UNITED STATES  
NUCLEAR REGULATORY COMMISSION  
WASHINGTON, D. C. 20555

DOCKET NO. 50-29

FACILITY: Yankee-Rowe

SUMMARY OF MEETING HELD ON JUNE 17, 1977, FOR BRIEFING ON MATTERS  
RELATING TO ECCS PERFORMANCE EVALUATION FOR YANKEE-ROWE

PRESENT SAFETY INJECTION SYSTEM

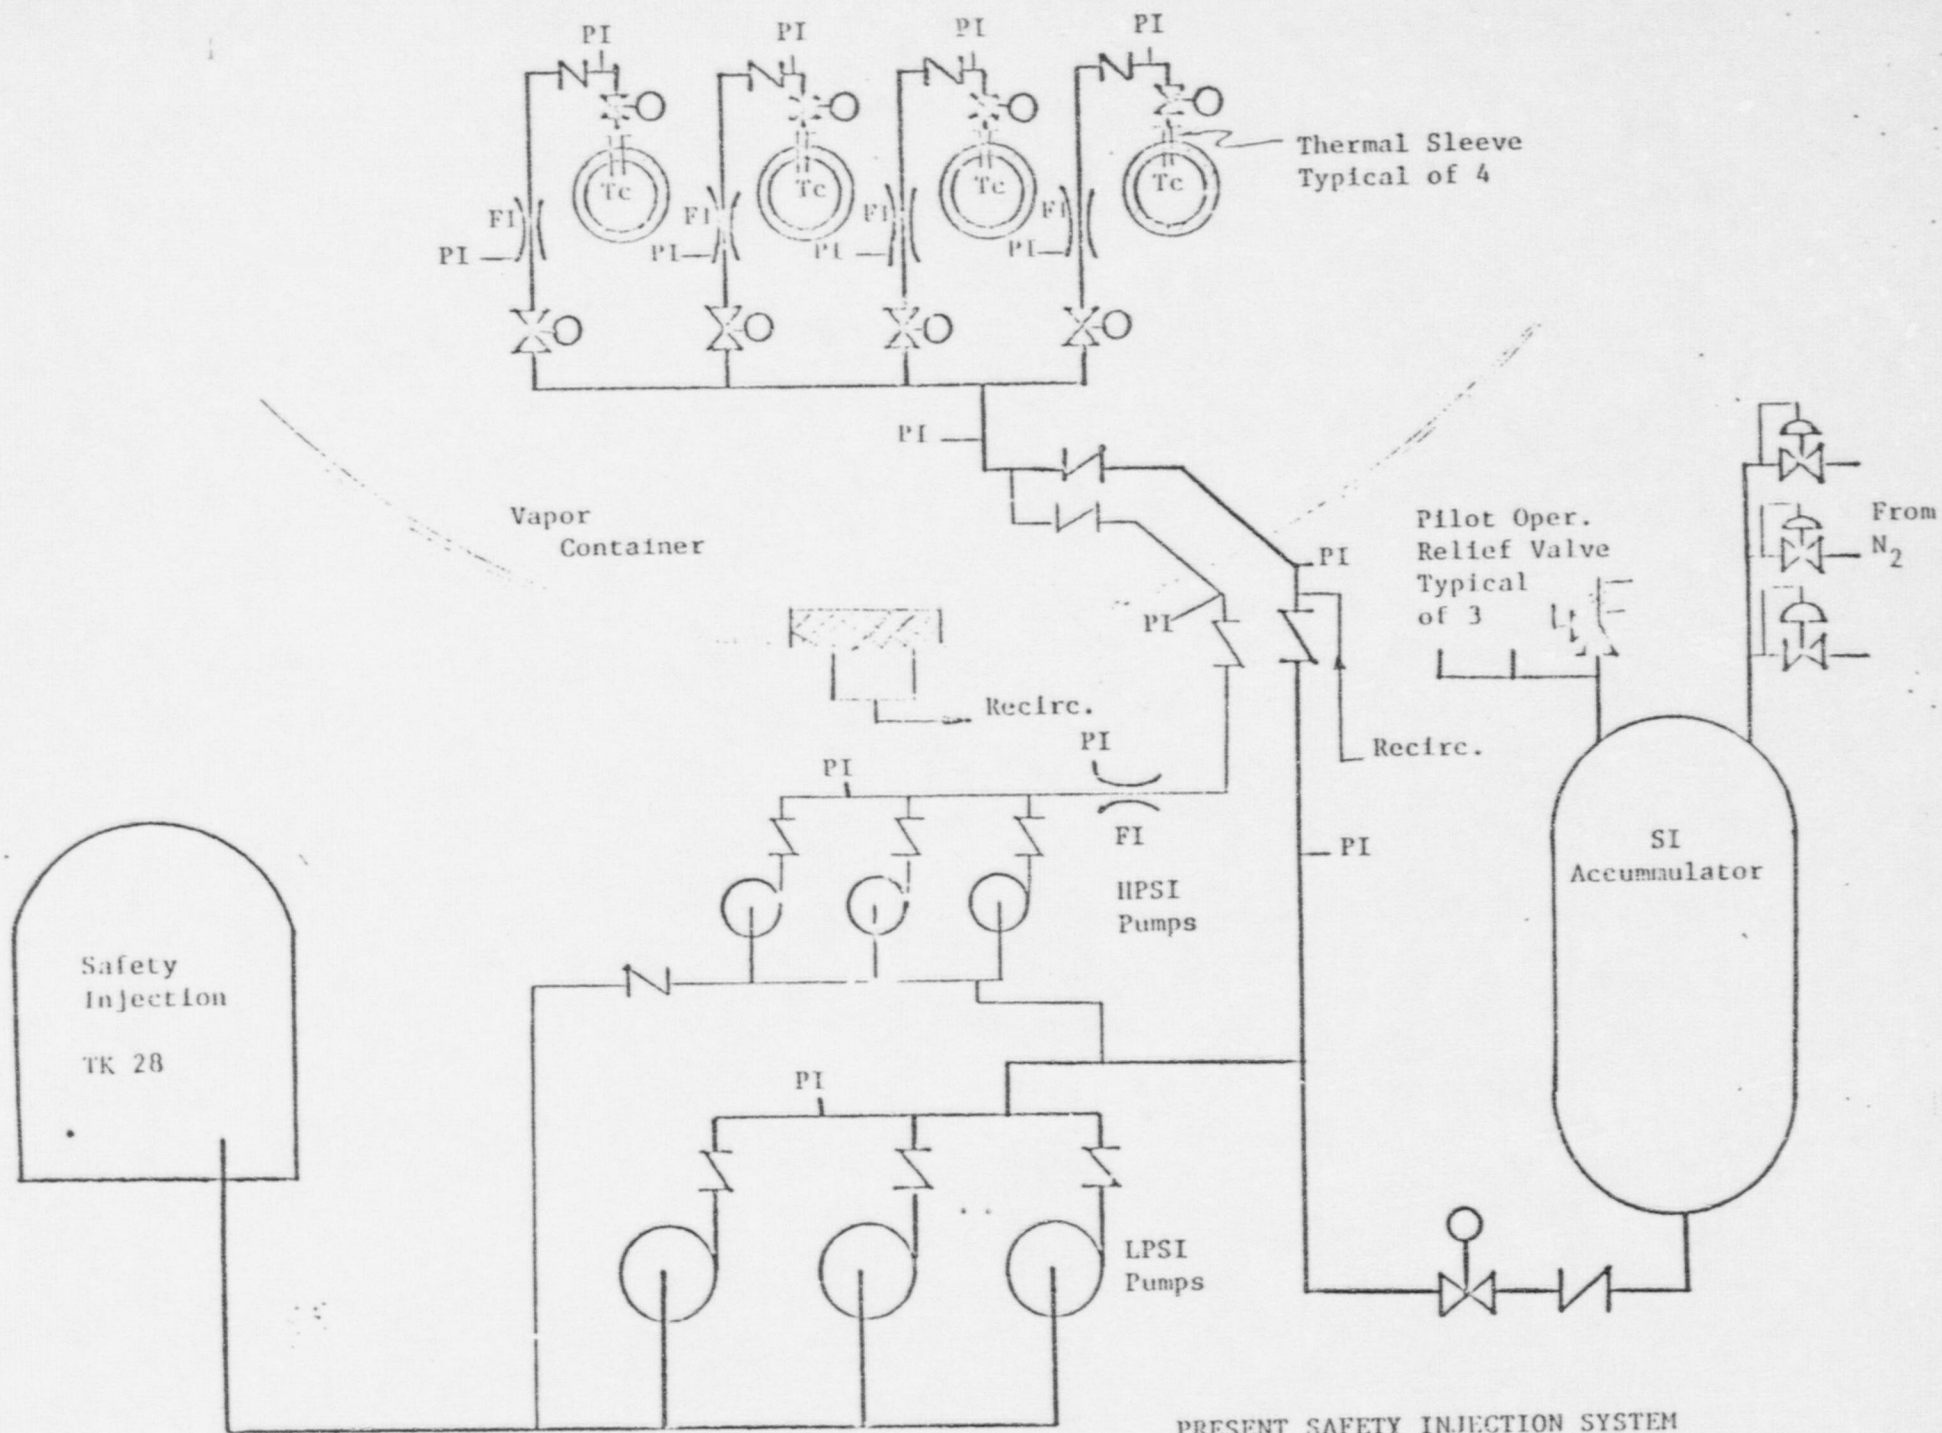
YANKEE INTENDS TO ASSUME ISOLATION OF FLOW TO THE BREAK IN THE CORE XIII ANALYSIS IN THE CASE OF THE BRANCH LINE BREAK DOWNSTREAM OF THE CHECK. THEREFORE, RESTORATION OF POWER TO THE BRANCH LINE VALVES AND THE RE-RECOGNITION OF OPERATOR ACTION ARE REQUIRED.

YANKEE PROPOSES TO RESTORE POWER TO CS-MOV-536, 537, 538, 539 AND SI-MOV-22, 23, 24, 25 WHICH WILL PROVIDE REDUNDANT CAPABILITY TO ISOLATE THE BROKEN BRANCH LINE, FROM THE CONTROL ROOM. RESTORATION OF POWER WILL PROVIDE PROTECTION AGAINST

OPERATOR ERROR AND SPURIOUS FAILURE IN ACCORDANCE WITH THE INTENT OF BTP-18.

ANALYSIS INDICATES THAT THE OPERATOR HAS 15 MINUTES TO IDENTIFY AND ISOLATE THE BROKEN BRANCH. YANKEE FEELS THAT OPERATOR ACTION WITHIN THIS TIME FRAME IS JUSTIFIED BECAUSE:

1. OPERATOR ACTION IS REQUIRED ONLY FOR A BREAK OF THE SI LINE DOWNSTREAM OF THE CHECK, AND
2. NO OTHER SHORT TERM OPERATOR ACTION IS REQUIRED.

IN ADDITION YANKEE PROPOSES TO PROVIDE IMPROVED RELIABILITY OF THIS ISOLATION CAPABILITY BY EITHER OF THE FOLLOWING:

1. RELOCATE THE DOWNSTREAM VALVES OUTSIDE THE LOOP, I.E. REMOTE FROM LOCA IMPACT, OR
2. INSTALL NEW REPLACEMENT VALVES OUTSIDE THE LOOP.

ELEMENTARY DIAGRAM FOR SI-MOV22  
SIMILAR FOR SI-MOV23, 24, & 25

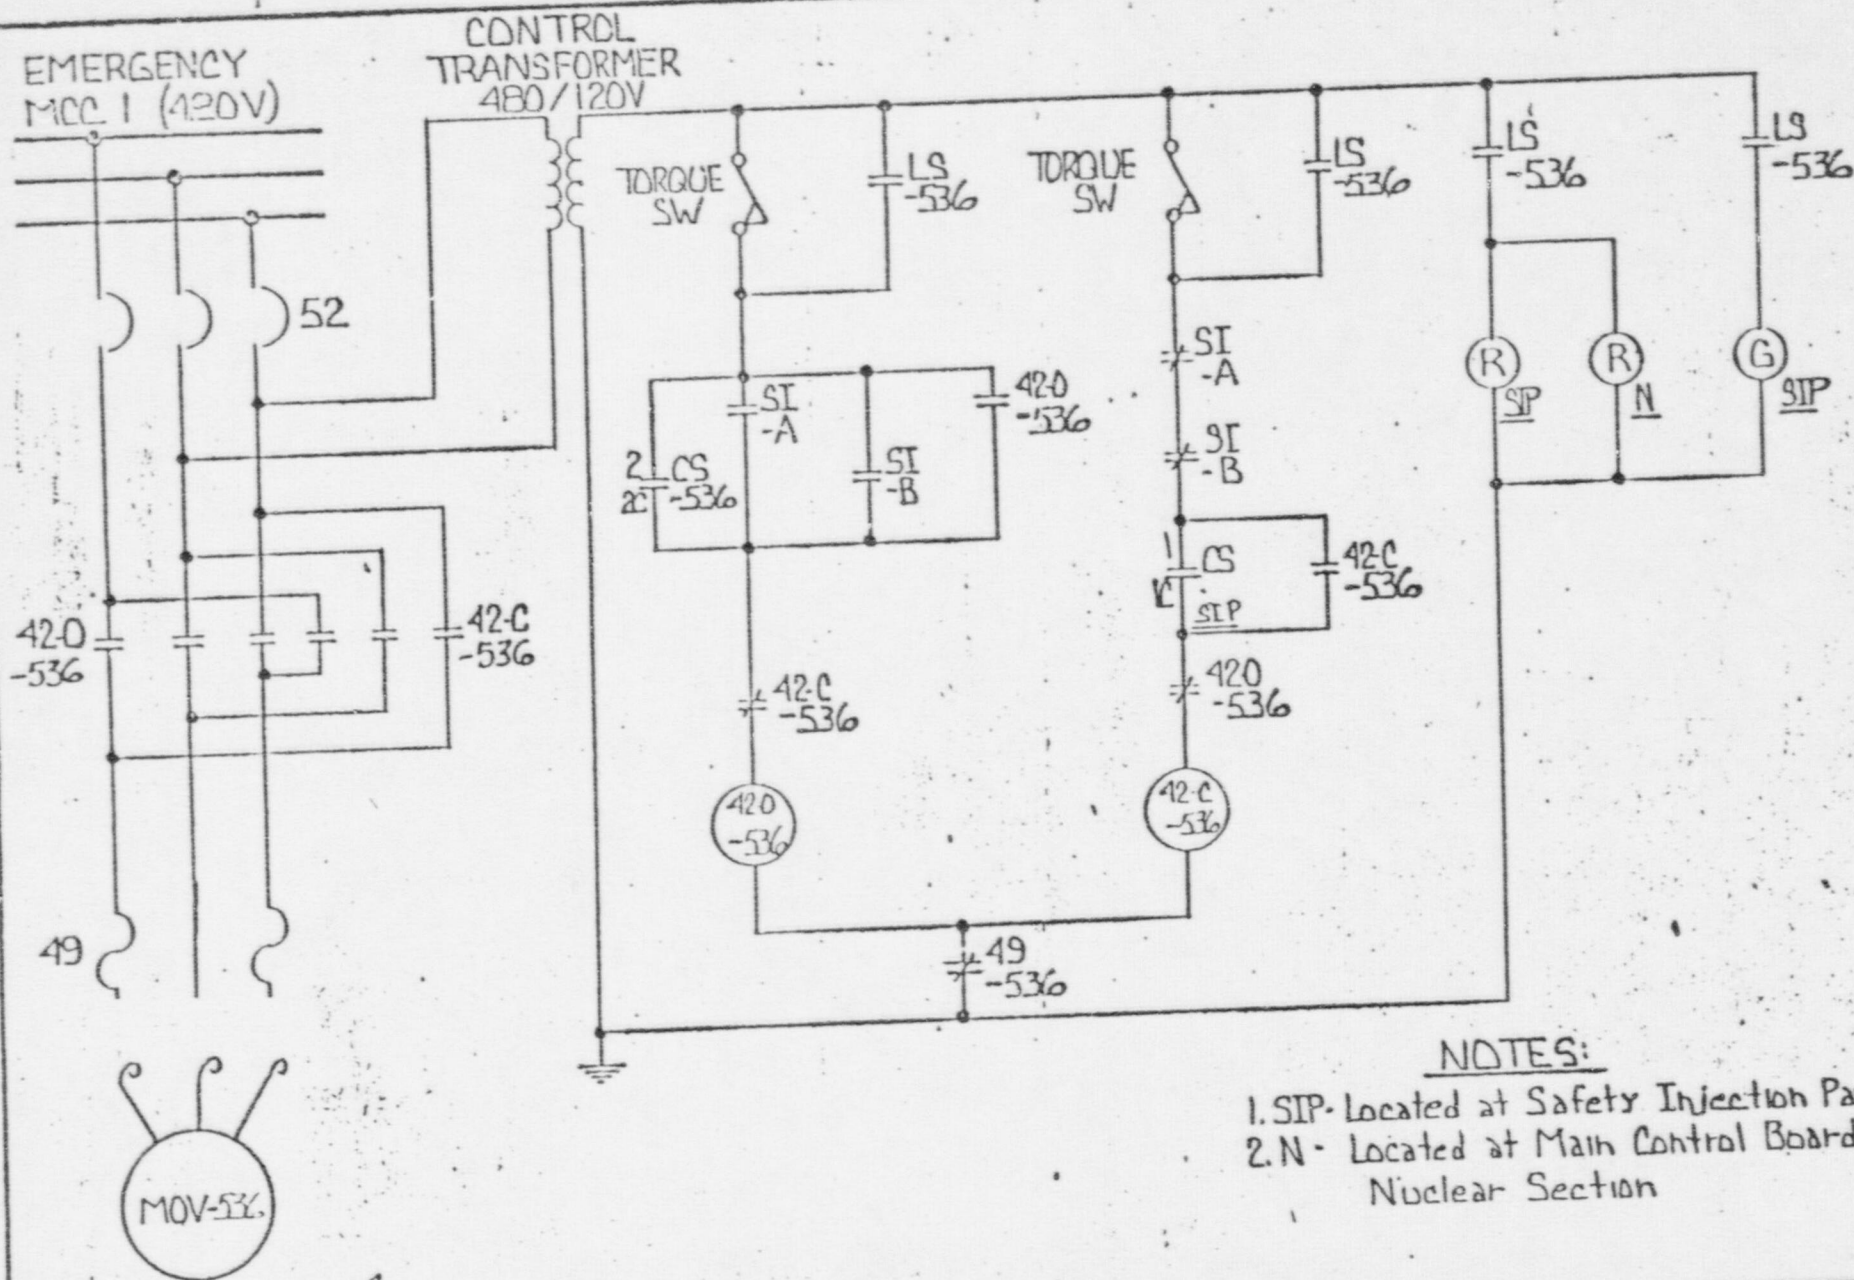
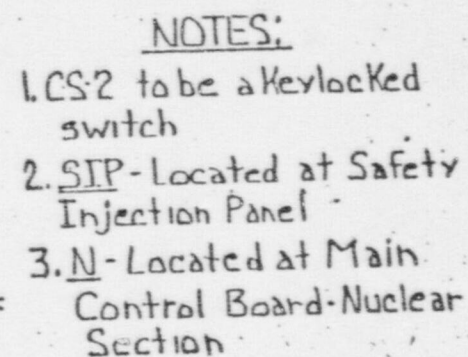
- A. Analytical modifications regarding heat transfer correlations.
- B. System Modifications
  - 1. Restore electrical power to eight safety injection valves.
  - 2. Add additional circuitry to effectively preclude spurious valve motion.
  - 3. Add keylock switches to essentially eliminate the possibility of operator error.
  - 4. Install safety injection valves in positions upstream of check valve in each injection line to provide redundant isolation capability remote from postulated break location.
